Detailed Site Plan DSP-20053-02
Departure from Design Standards DPT-2025-0003
West Hyattsville Phase 2 - ETOD

SUBJECT: Detailed Site Plan DSP-20053-02
Departure from Design Standards DPT-2025-0003
Type 2 Tree Conservation Plan TCP2-2025-0074
Alternative Compliance ACL-2025-0008
Expedited Transit-Oriented Development (ETOD) Project
West Hyattsville Phase 2

The Urban Design Section has reviewed the subject application and presents the following evaluation and findings leading to a recommendation of APPROVAL, with conditions, as described in the Recommendation section of this technical staff report.

A304

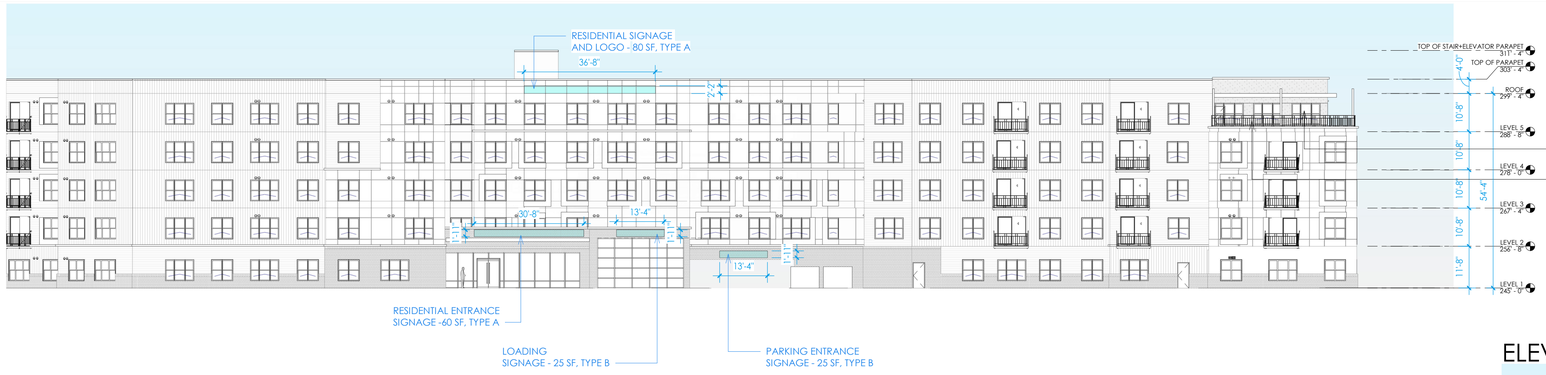
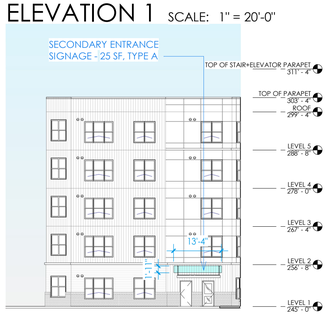
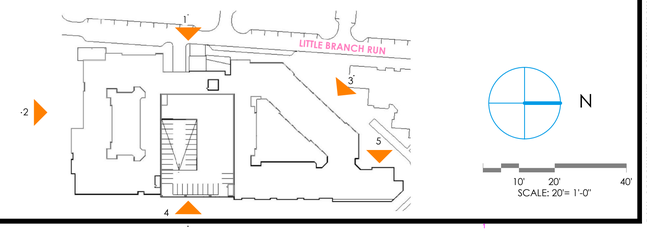
Signage
A uniform signage plan (shown on Sheets A304 and A305) has been submitted with this DSP that includes signs for the residential use and entrances. The specific sign types and locations have been shown on each elevation of the building complex, and specific sign face areas have also been provided. A summary sign face area calculation table has been provided that shows a total of 395 square feet of signage for the entire project. However, sign lettering, color, style, materials, and installation details have not been provided and should prior to certification, as conditioned herein.

m. Revise the signage package to provide details for each proposed sign.
